## Dirt Track Rule Change Log

Date Changed: 4/22/2010 Rulebook Version #: 3 Effective Date: 5/1/2010

Examples:

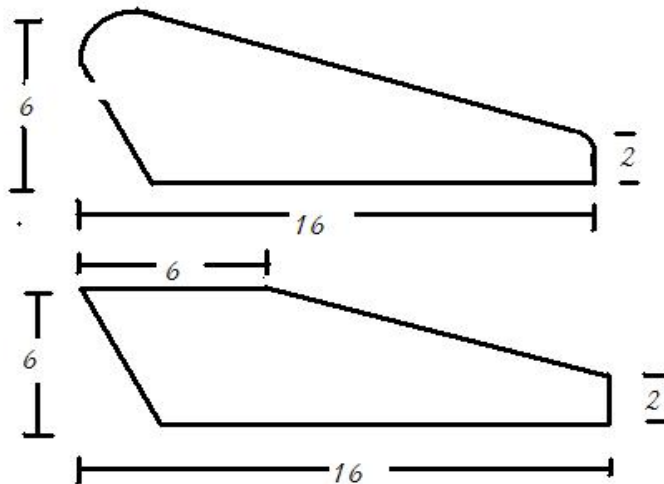
A 5" spoiler is allowed. The spoiler will be measured from the deck up not including the mounting area or the mounting lip on the top tin. The spoiler must be mounted flat to the top tin on the rear of car and cannot be wider than sixty eight inches (68"). No gaps will be allowed between the spoiler and the top tin. All spoiler supports must slope down towards the front of the car similar to the examples shown.

Spoiler supports can be no longer than sixteen (16") inches and a maximum height of six (6") inches tall. All Spoiler supports must taper down to a maximum height of two (2") inches at the front of the support. The center support shall be the same design and height as the end panels.
